Town of Arlington, MA Redevelopment Board

Agenda & Meeting Notice August 7, 2017

RE: Design Changes to 483 Summer St Project

**RE: Environmental Design Review & Special Permit Request Relating to
887 Massachusetts Avenue, Arlington, Massachusetts**

Campobasso Properties, LLC	
483 Summer Street	
Cellar Plan	
Date	7/31/17
Drawn by	CP LLC
A-0	
Scale	1/4" = 1'-0"

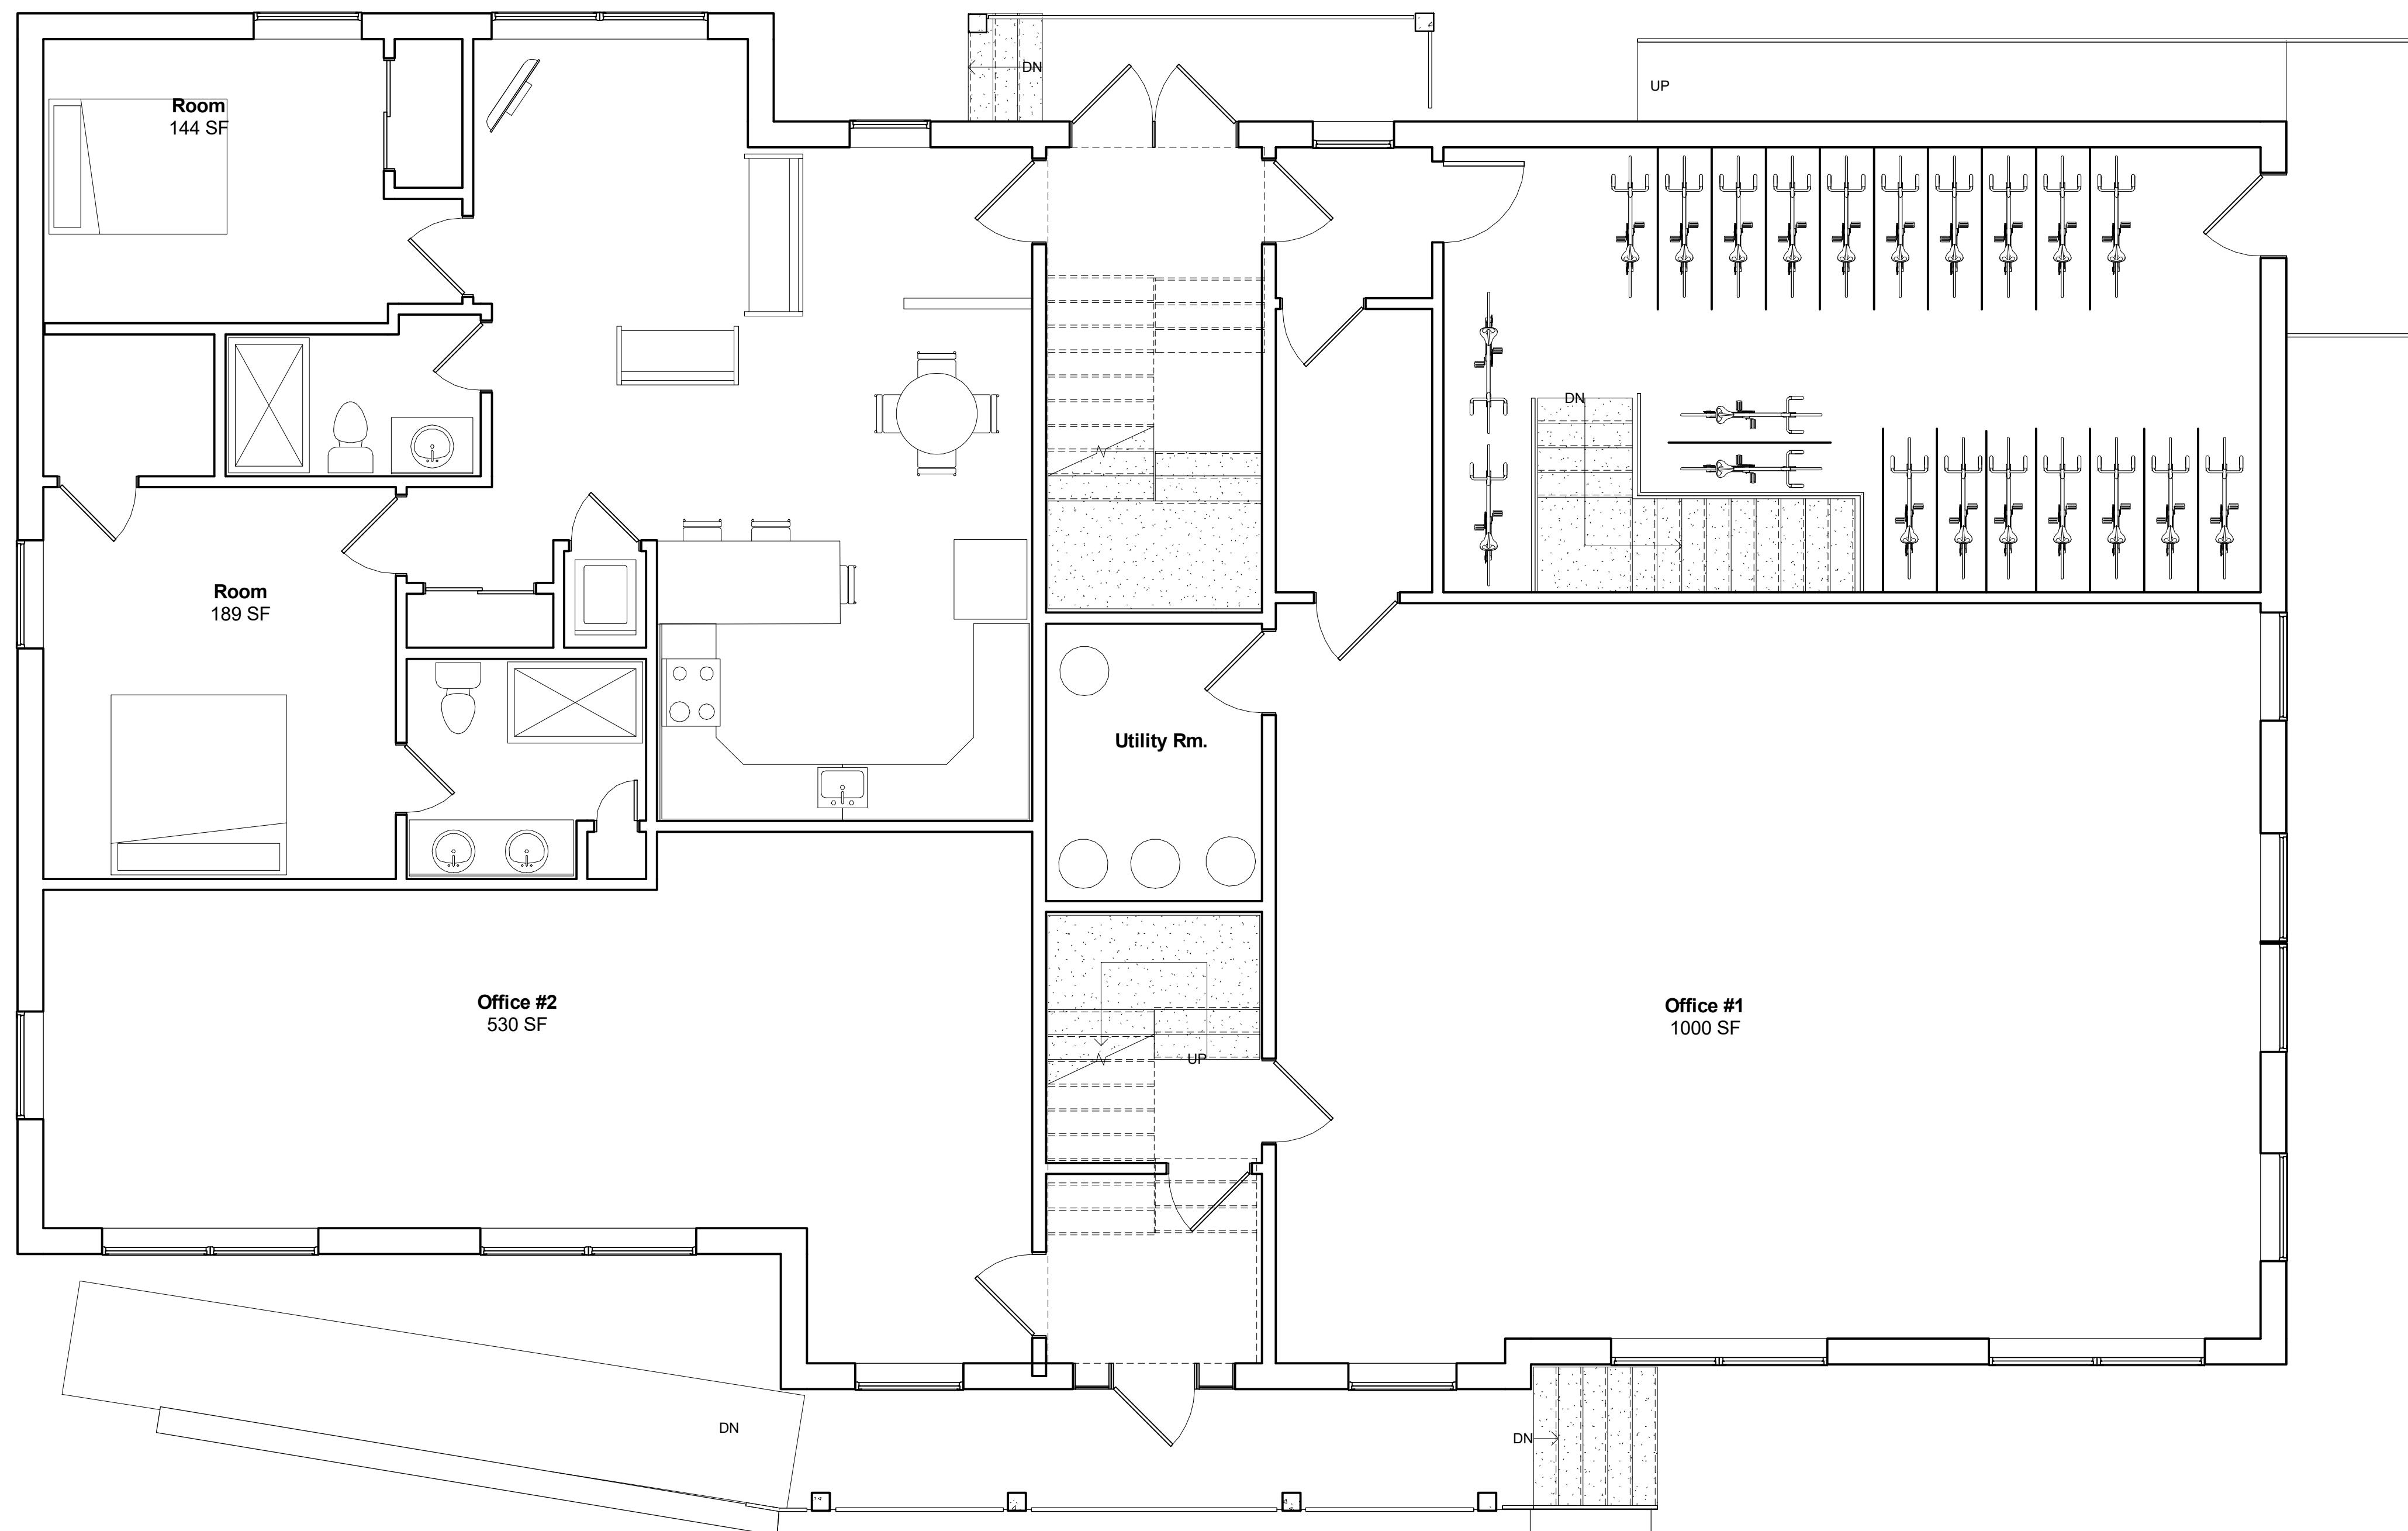
- A-0 – Cellar Plan: The basement has been reduced in size. This eliminated the need for additional retaining walls, soil removal, and the additional retail storage.

Campobasso
Properties, LLC
483 Summer Street
Level 1 Plan
Date 7/31/17
Drawn by CP LLC
A-1
Scale 1/4" = 1'-0"

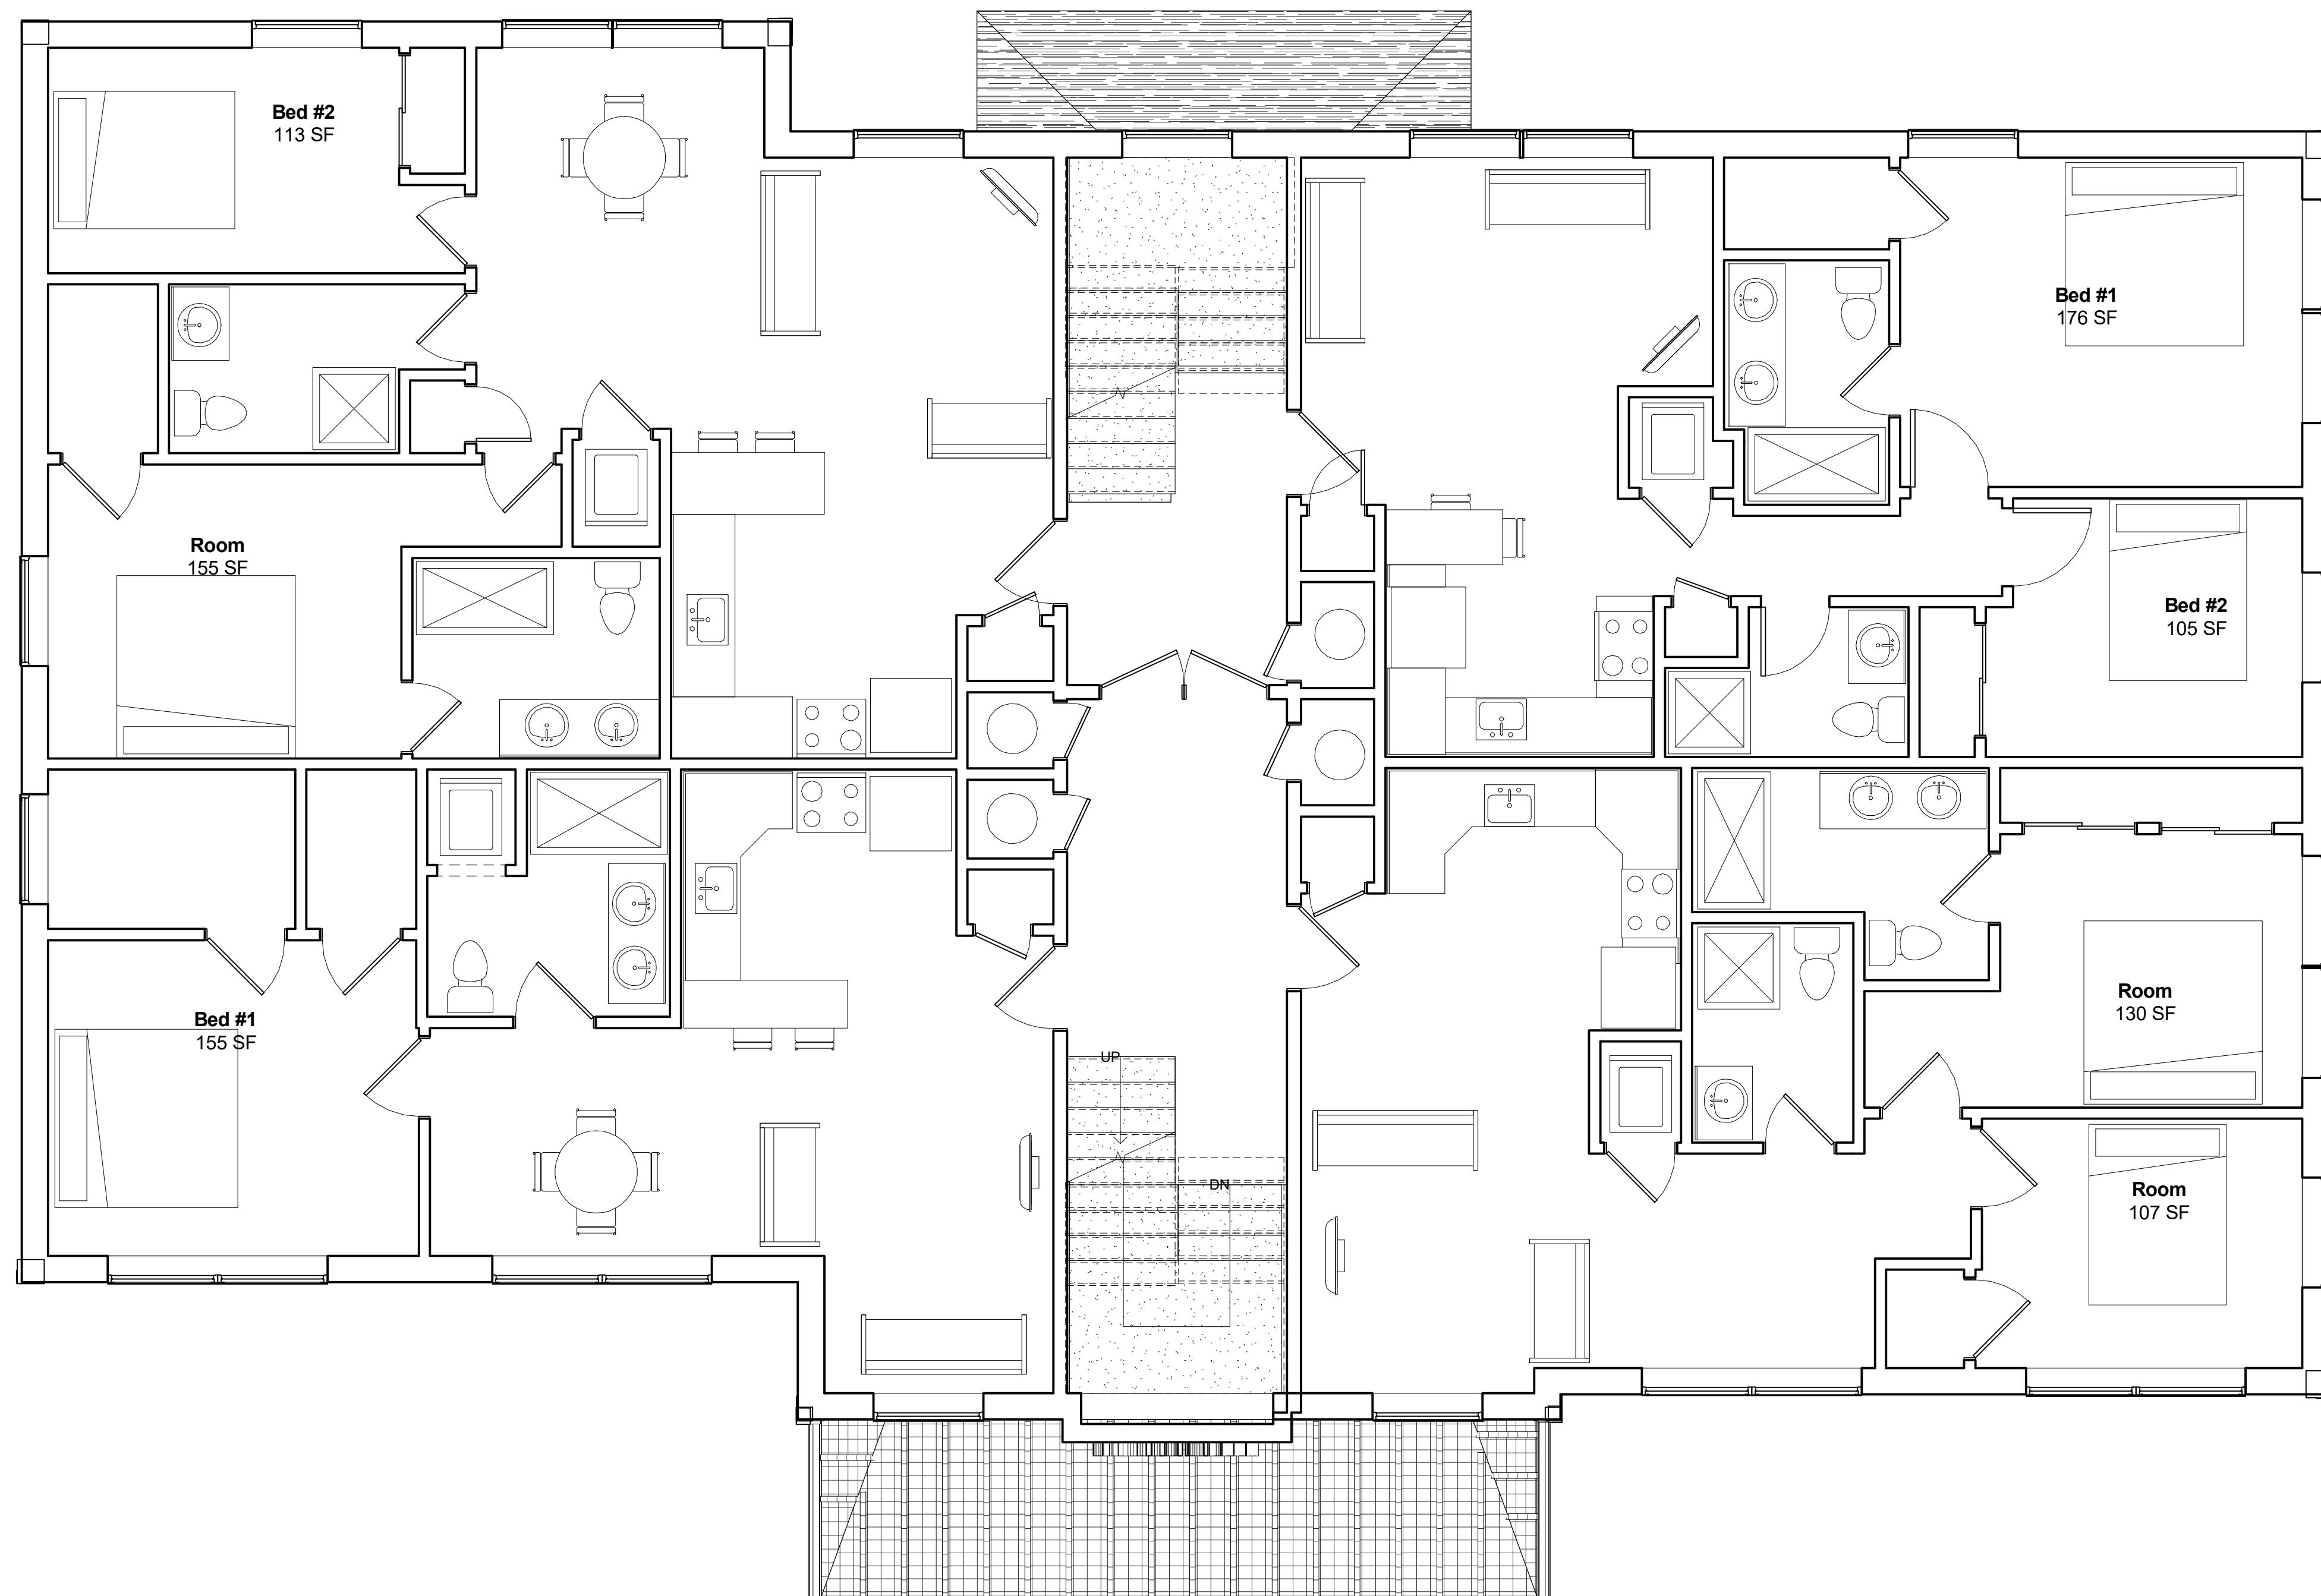
- A-1 – Level 1 Plan: The first floor will remain at one constant elevation in all directions. The four retail spots will be eliminated and replaced with two offices, one 2-bedroom apartment unit and indoor bicycle/utility areas.

Campobasso
Properties, LLC
483 Summer Street
Level 2 Plan
Date 7/31/17
Drawn by CP LLC
Scale 1/4" = 1'-0"
A-2

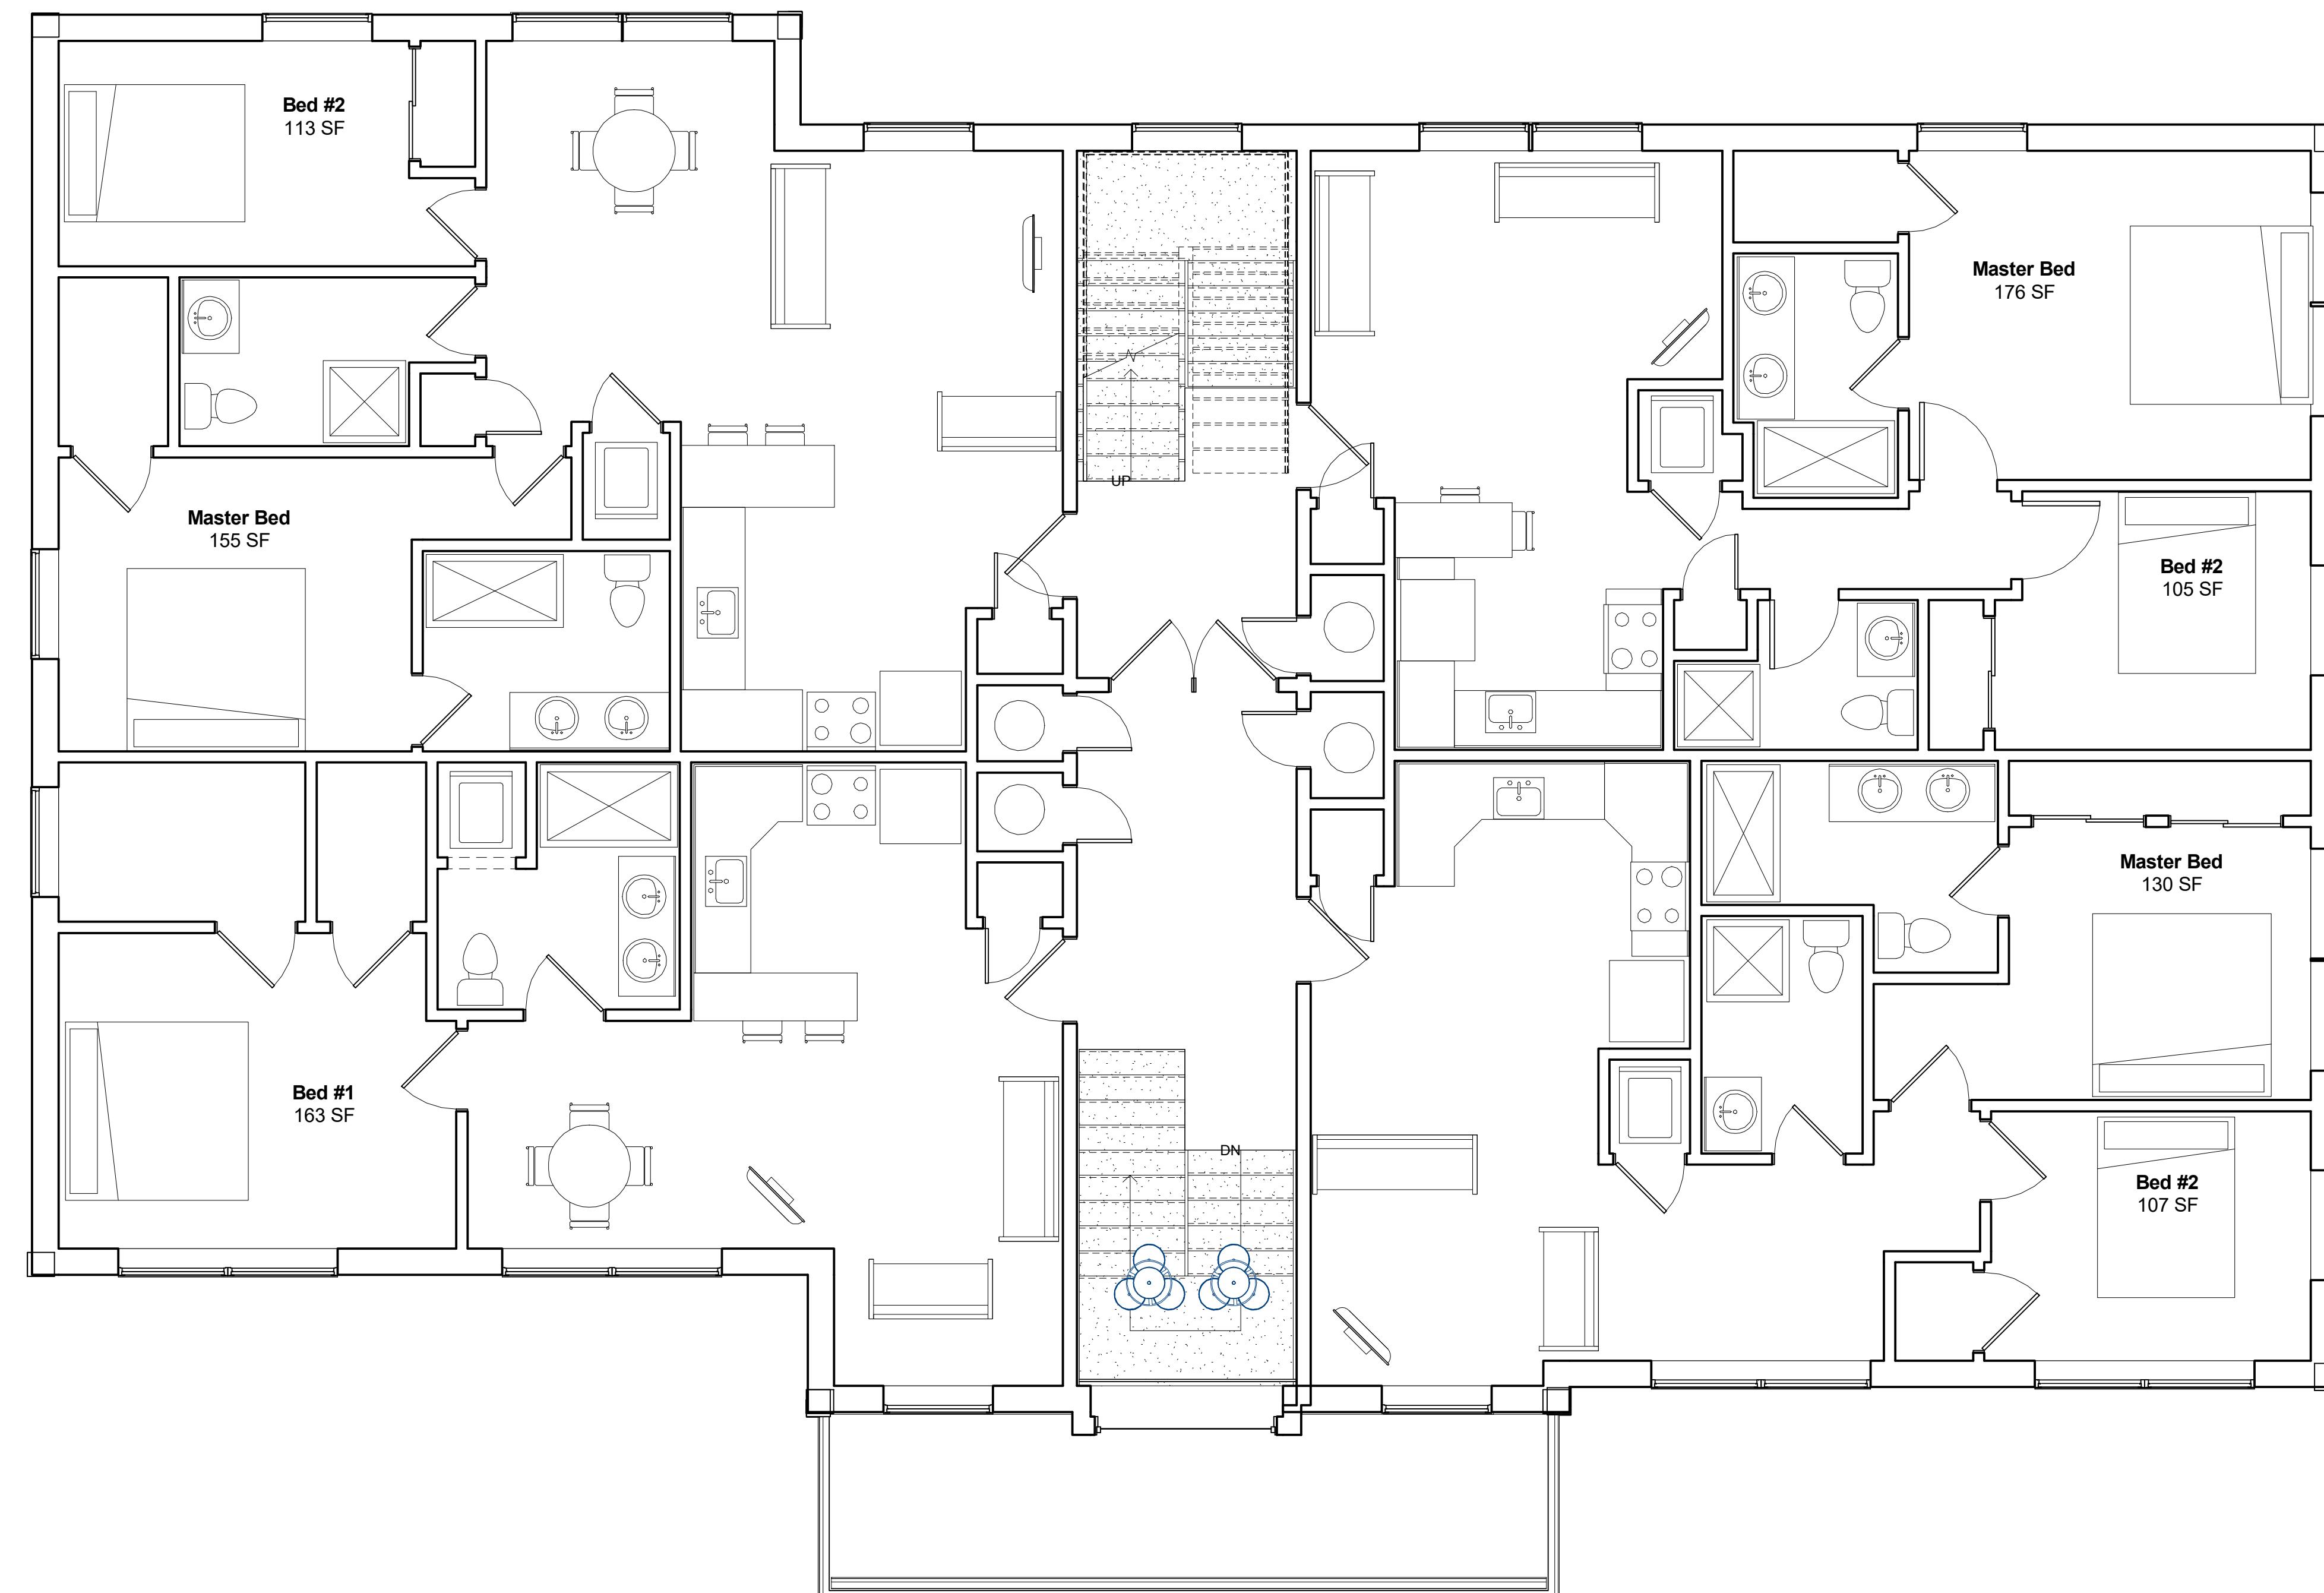
- A-2 – Level 2 Plan: The office will be removed on the 2nd floor and replaced with a one-bedroom apartment. The layout of the apartments will remain ultimately the same with some minor adjustments made for window placements.
